# AEMC Rule Change - Efficient Reactive Current

Reference ERC0272

24 January 2023

## Comments on Rule Change Justification

Figure D.1: Simplified equivalent circuit for a short circuit

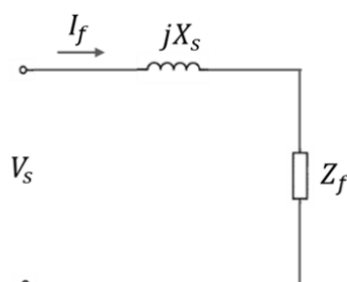
- If  $Z_f = 0$  then current will be inductive
- This example assumes that **reactive power** is inductive, and that capacitive current is something else. It should say "illustrate that the fault current is mostly inductive in nature. It is not clear how the fault current can be capacitive? Perhaps AEMC/Aurecon could explain this?"

Figure D.10: Temporary over voltage

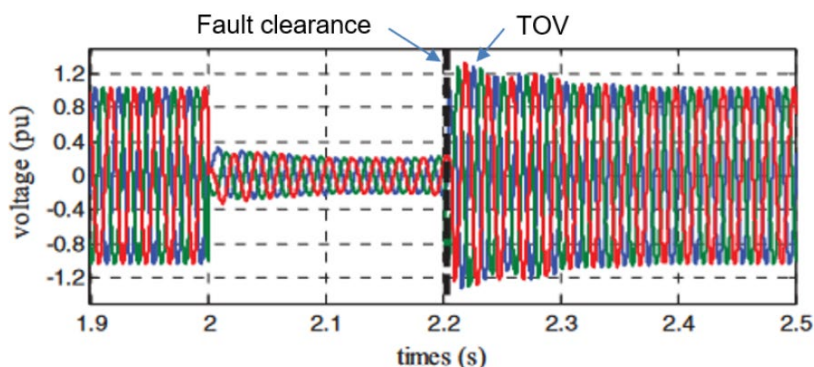
The fault shown here is a balanced three-phase fault and yet TOV is greater than 120%. Why doesn't AEMC/Aurecon show the impact of reactive injection on the healthy phases of a single phase-ground fault? The original AEMO rule for 4%  $\Delta Q$ /1%  $\Delta V$  never considered this issue, yet it impacts significantly on power system security and can stress and damage equipment.
